**Gore RCN-8818 Cable  
for RBSP Spin Plane Boom  
RBSP-SPB-TN-025 Rev B**

Detailed Inspection  
Performed by Greg Dalton 1/8/09  
Space Sciences Lab – UC Berkeley  
UCB PO# 1-0001382652  
Gore PO A74-32016  
Sales Order #13807978  
Work Order #2294768

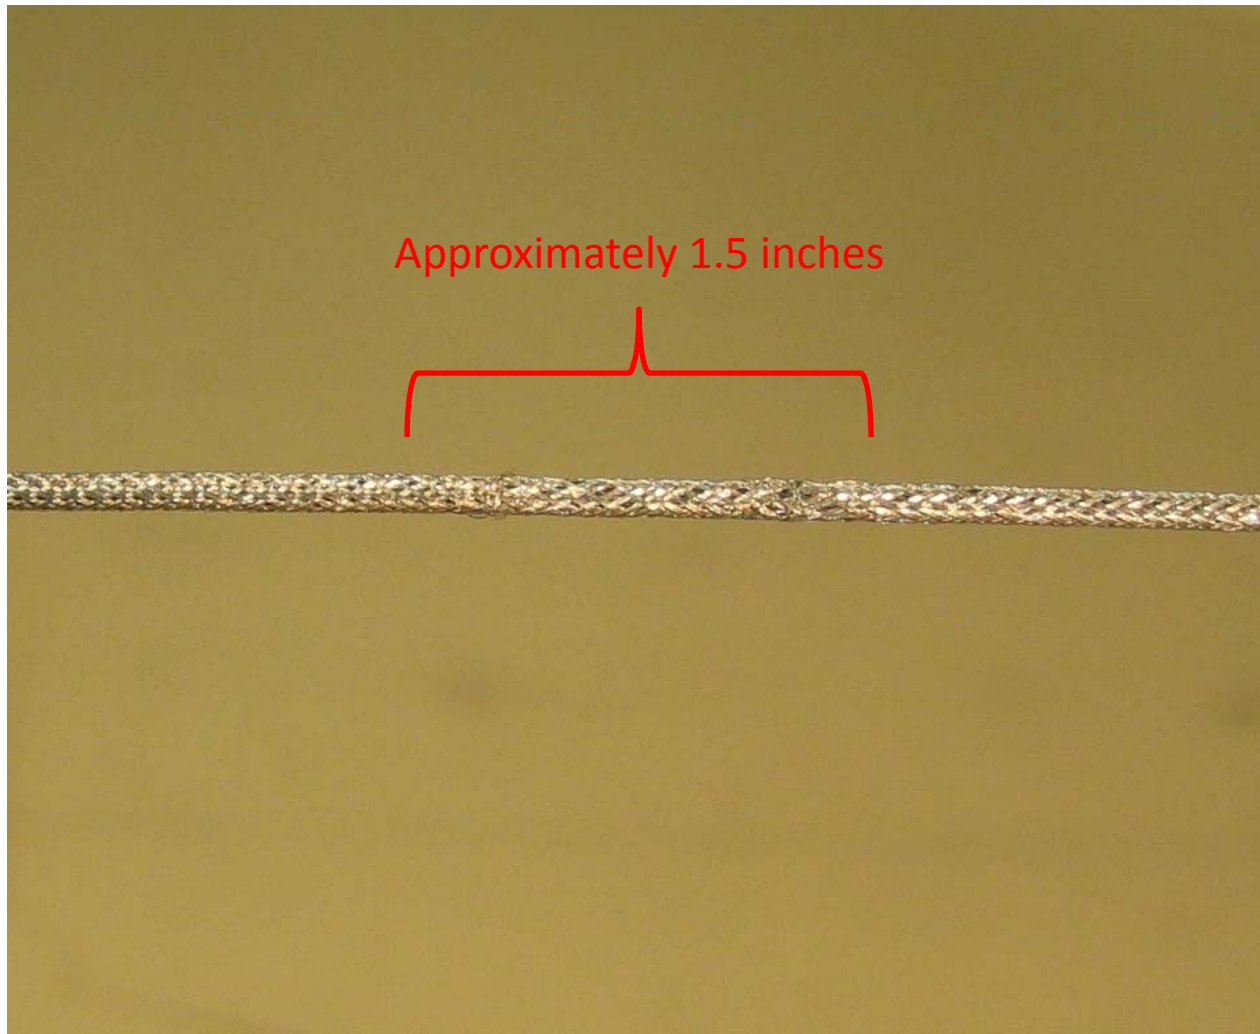
At the 2313 ft mark, an SPC braid defect with other smaller defects within 6 in.
